ADDENDUM NO. 2

Issued by: Sacramento City Unified School District

Project: Project #: 0029-401 Bret Harte Playground

| DSA STAM |
|--|
| TOILET ROOM PLANS AND ELEVATIONS |

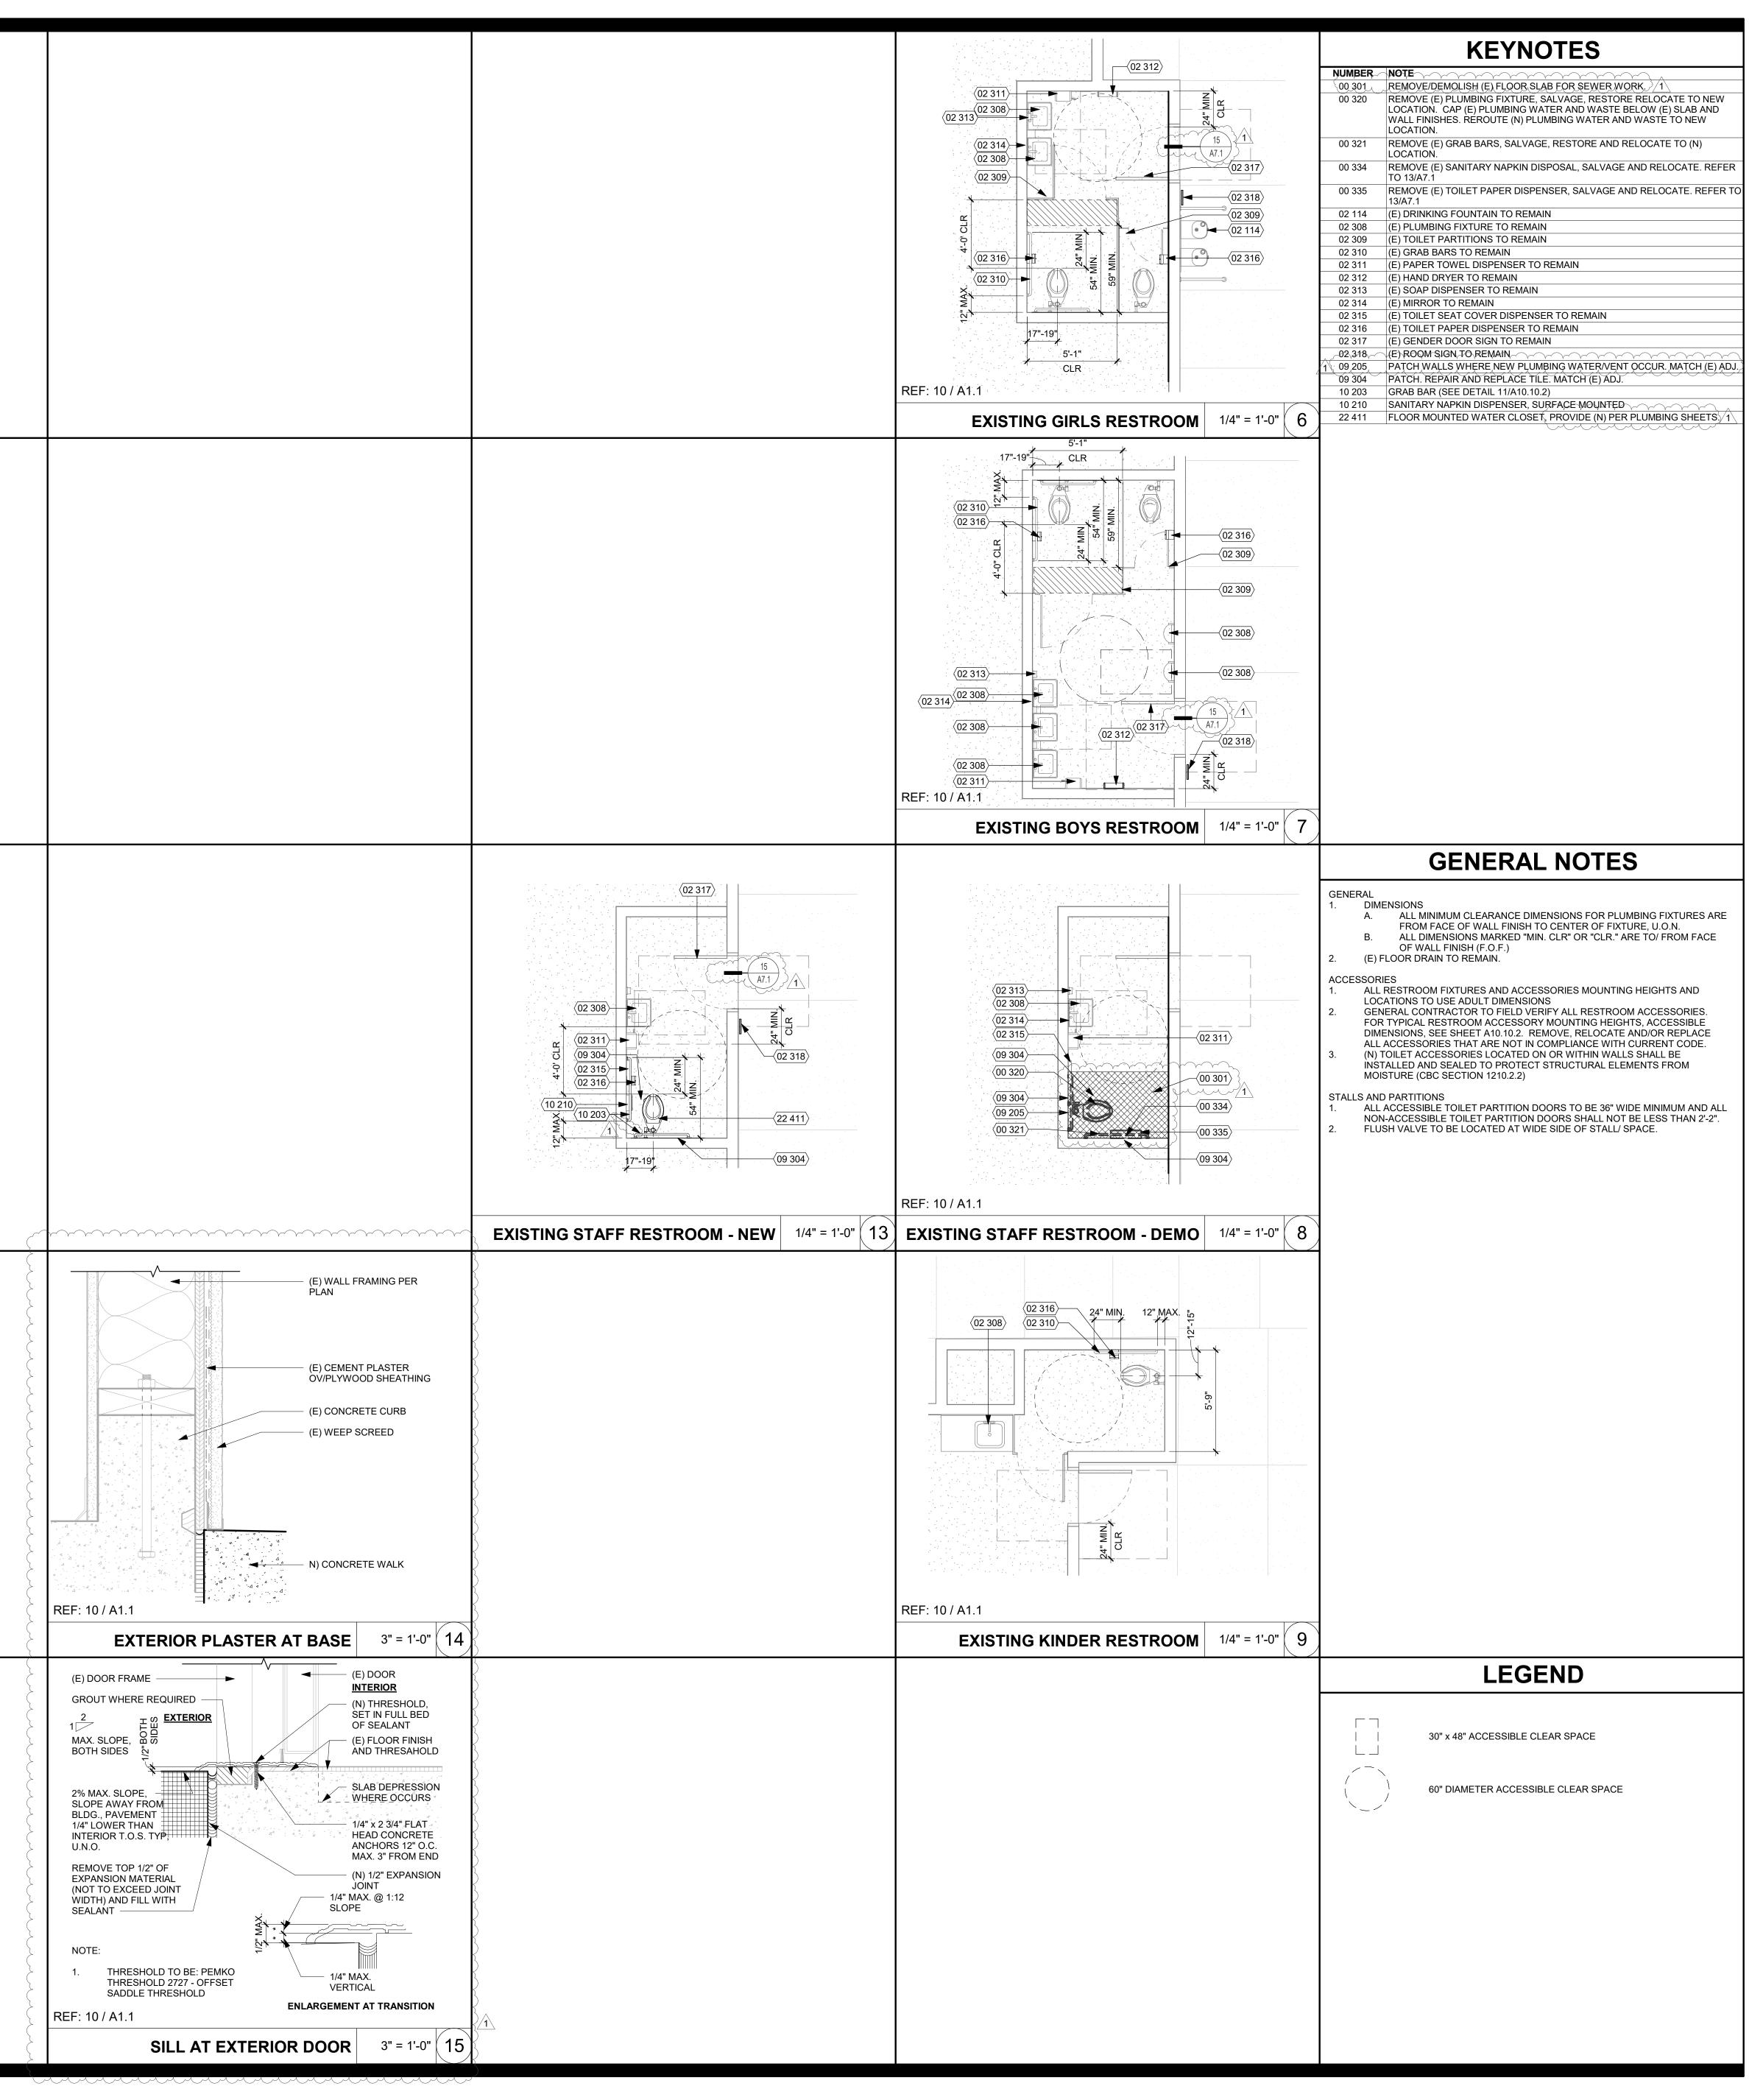
- N. SHEET A7.1:
 - 1. Revise Keynote 22 411 to "Floor mounted water closet, provide new per plumbing sheets"
 - 2. Add Keynote 00 301 REMOVE/DEMOLISH (E) FLOOR SLAB FOR SEWER WORK

- 3. Add Keynote 09 205 PATCH WALLS WHERE NEW PLUMBING WATER/VENT OCCUR. MATCH (E) ADJ
 - 4. Added hatch where slab demo occurs
 - 5. Detail 14/A7.1 (E) Exterior Plaster at Base has been added

- 6. Detail 15/A7.1 (E) Sill at Exterior Door has been added
 - 7. Call outs for Detail 15/A7.1 have been added to 6A/7.1 Existing Girl's Restroom, 7/A7.1 Existing Boy's Restroom, and 13/A7.1 Existing Staff restroom New
